MIL-C-25601C(USAF)
AMENDMENT 2
26 January 1971

MILITARY SPECIFICATION

COUPLER, ANTENNA
CU-308D/U

This amendment forms a part of Military Specification
MIL-C-25601C(USAF), dated 16 October 1970

FIGURE 8 Antenna coupler CU-308 D/U

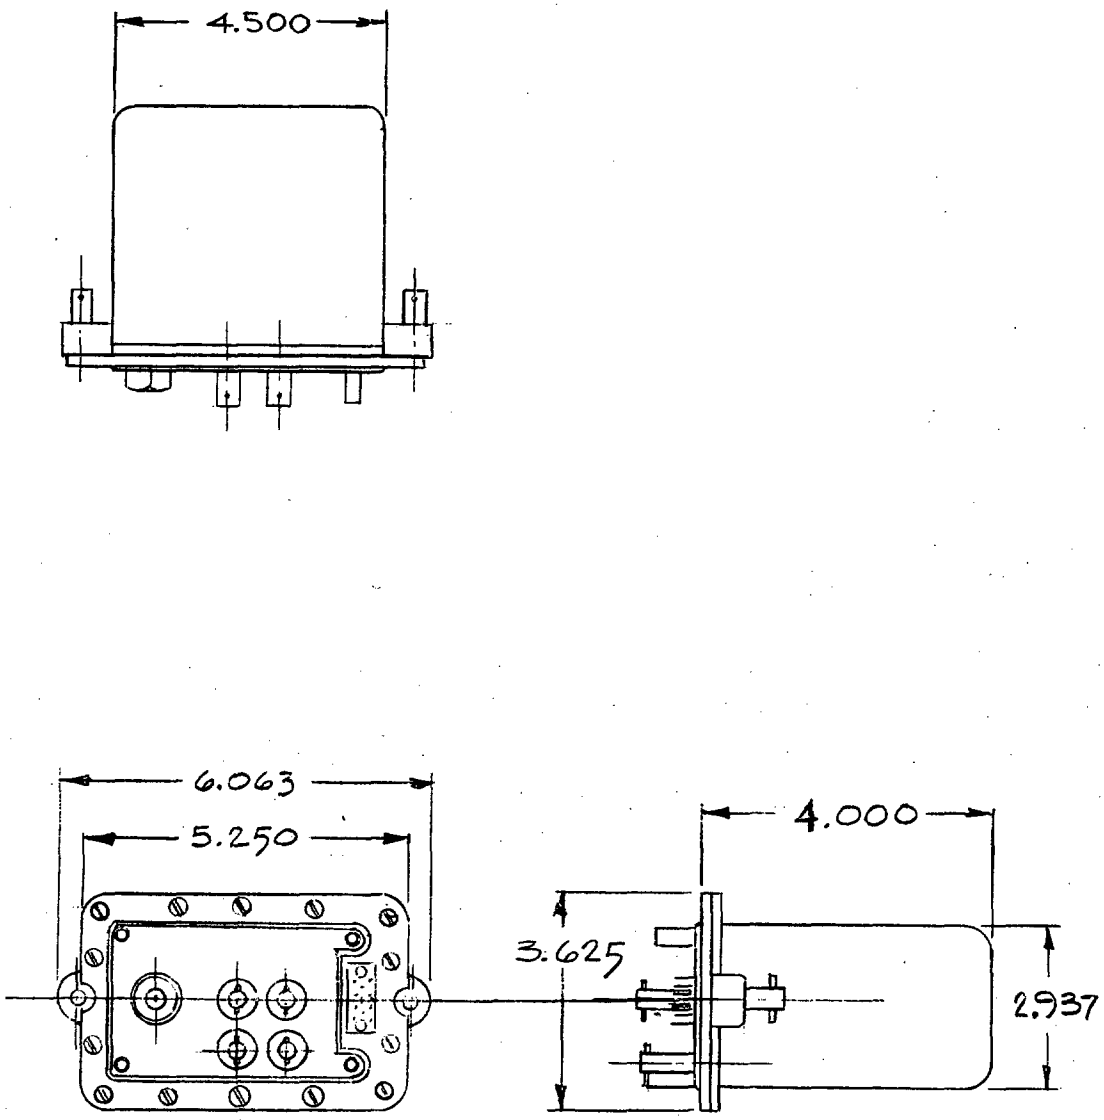
Page 21, figure 7, front view: Delete "6.00 inches" as coupler face width and substitute "5.25 inches".

FIGURE 9 Overvoltage transient tests

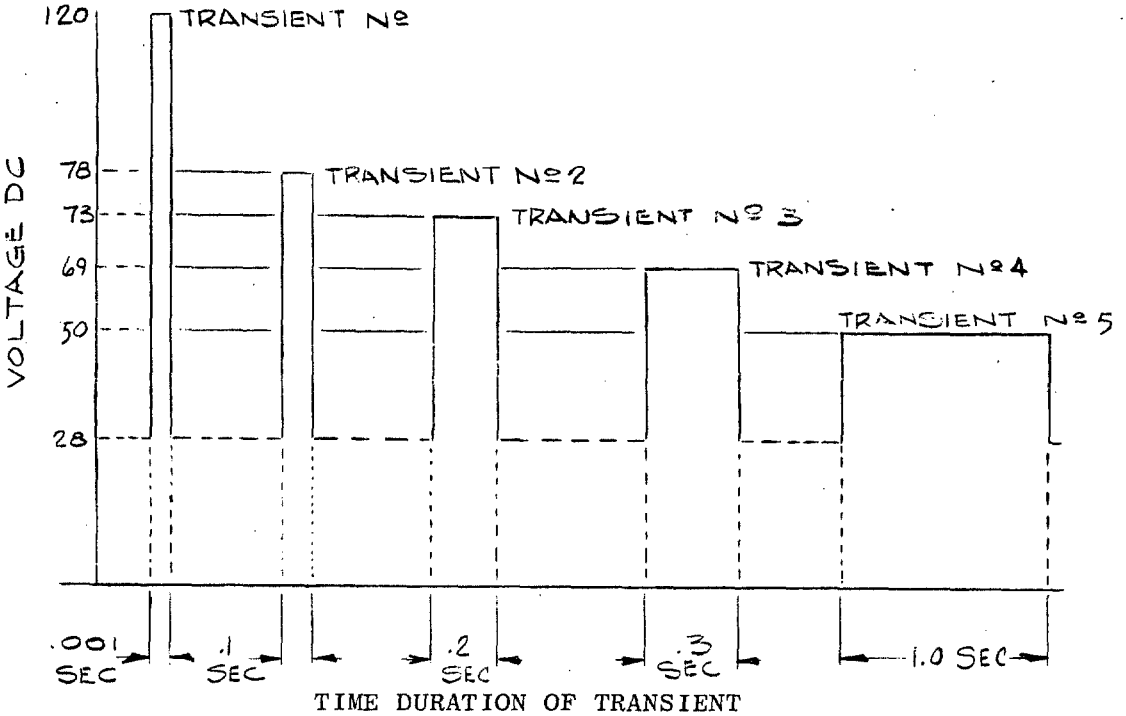
"4.6.2.3 Power Source Transient Response.- The coupler shall be tested in accordance with MIL-STD-704 and in addition must accept spikes of plus 120 VDC for 0.001 second duration as shown in figure 9 and minus 400 VDC for 0.001 second duration as shown in figure 10. Each of the five transients in the figures shall be repeated at least three times. The intervals between transients shall not be less than 30 seconds. Tolerances shall be ±2% on voltages and ±10% in time intervals".
